Access Compliance Report

Public Rights-of-Way

(Island Curb Cuts)

| Intersection ID: 45096 | Main Street: E_9TH_ST | Cross Street: N_DAVIDSON_ST | Location: NE |

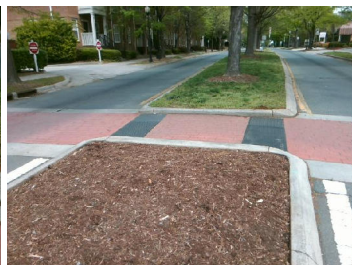
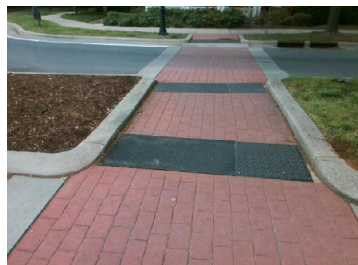
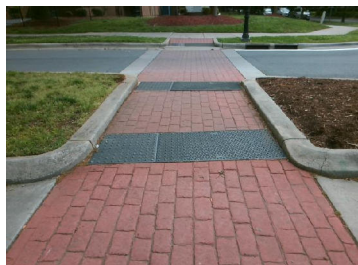
| ADA ID: 9AC703F5763C | Curb Cut Type: MedianRefuge2 | Initial Pass/Fail: Fail | Overall Compliance: No |

Possible Solutions:

Remove & Replace Entire Refuge.
